Access Compliance Report

Public Rights-of-Way

(Curb Ramps)

Intersection ID: 19313	Main Street: RANDOLPH_RD	Cross Street: SARDIS_RD	Location:	W
ADA ID: 858CE54EF8E2	Ramp Type: Perp	Initial Pass/Fail: Fail	Overall Compliance: No	Severity Score: 25
Codes/Mitigation Info/Possible Solution		Field Measurements/Component Compliance

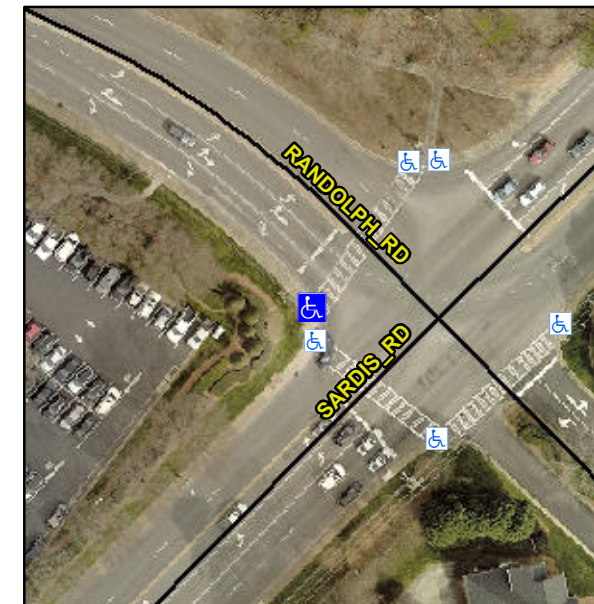
Not Found, R304.5.3

Compliance	Description	Data	Compliance	Description	Data
N/A	Ramp Length (in)	74.0	Yes	Ramp Slope (%)	7.6
Yes	Ramp Width (in)	48.0	No	Ramp XSlope (%)	7.5
N/A	Flare Type LT	N/A	N/A	Flare Type RT	N/A
N/A	Flare Slope LT (%)	N/A	N/A	Flare Slope RT (%)	N/A
N/A	Flare Traversable LT?	N/A	N/A	Flare Traversable RT?	N/A
N/A	Landing Length (in)	N/A	N/A	DWS Provided?	N/A
N/A	Landing Width (in)	N/A	N/A	DWS Contrast?	N/A
N/A	Landing Slope (%)	N/A	N/A	DWS Length (in)	N/A
N/A	Landing X Slope (%)	N/A	N/A	DWS Full Width?	N/A
N/A	Landing Curb? (Y/N)	N/A	N/A	DWS Offset (in)	N/A
N/A	Shared Landing?	N/A			
N/A	Gutter Ponding?	N/A	N/A	Gutter Slope (%)	N/A
N/A	Gutter Lip Ht (in)	N/A	N/A	Gutter X Slope (%)	N/A
N/A	Painted X Walk1?	Yes	N/A	Painted X Walk2?	N/A
	X Walk 1 Direction	To NE		X Walk 2 Direction	N/A
N/A	X Walk 1 Width (in)	116.0	N/A	X Walk 2 Width (in)	N/A
	X Walk 1 Slope (%)	2.0		X Walk 2 Slope (%)	N/A
	X Walk 1 X Slope (%)	8.6		X Walk 2 X Slope (%)	N/A

Remove & Replace Entire Ramp.
